IMPORTANT SAFETY MESSAGE

IMMEDIATE ACTION REQUIRED: Supra Series S6, S7, S8 & S9 Diesel Truck Refrigeration Units

SERVICE BULLETIN

SUBJECT: IMMEDIATE ACTION REQUIRED: Supra® Series Battery and Standby Cabling Routing Inspection and Correction

Figure 2

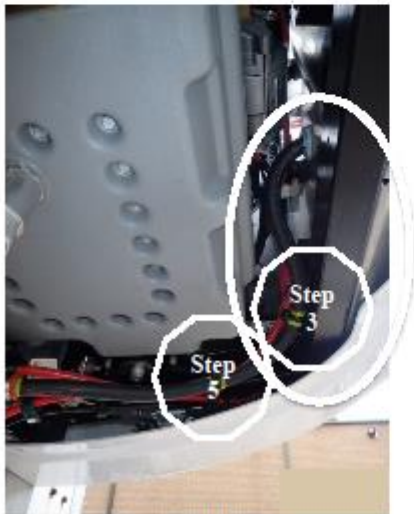
4. Secure high voltage standby cable with heavy duty ty-wrap (part # 44-60024-25). Ty-wrap should be installed approximately 9.5 inches from exit point of control box. Ensure cable is not pulled so tight it creates a gap around rubber grommet in control box (see Figure 2).

Figure 3

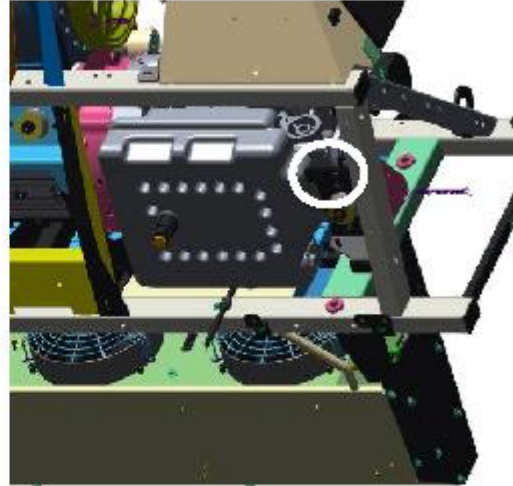
5. Insert fir tree ty-wrap base (part # 44-60121-00) in hole provided in the bottom of the frame located by the motor mount (see Figures 2 and 3).

Figure 6

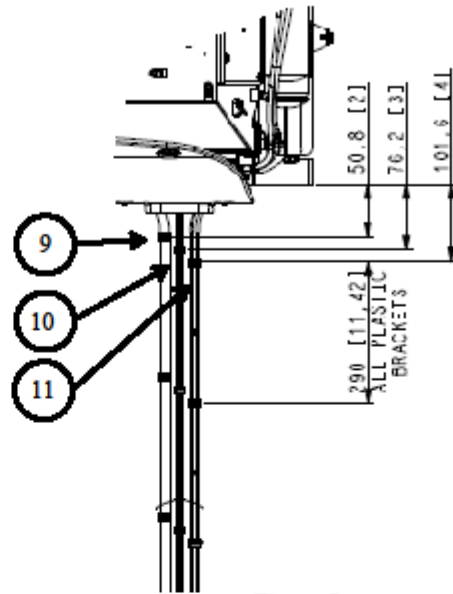
9. Secure the standby cable down the front wall of the truck body. The first securing point should be approximately 2 inches down from the bottom of the unit frame and every 12 inches all the way to the bottom of the truck body (see Figure 6).

10. Secure the positive battery cable, cab command cable and fuel pump cable, with the first securing point approximately 3 inches down from the bottom of the unit frame. Secure these cables every 12 inches down the front wall of the truck body. The securing point should be stagger from the standby cable (see Figure 6).

11. Secure the negative battery cable and the two fuel lines, with the first securing point approximately 4 inches down from the bottom of the unit frame. Continue to secure the negative battery cable and fuel lines down the front wall of the truck body every 12 inches. These securing points should be staggered to the positive battery, cab command and fuel pump cables (see Figure 6).
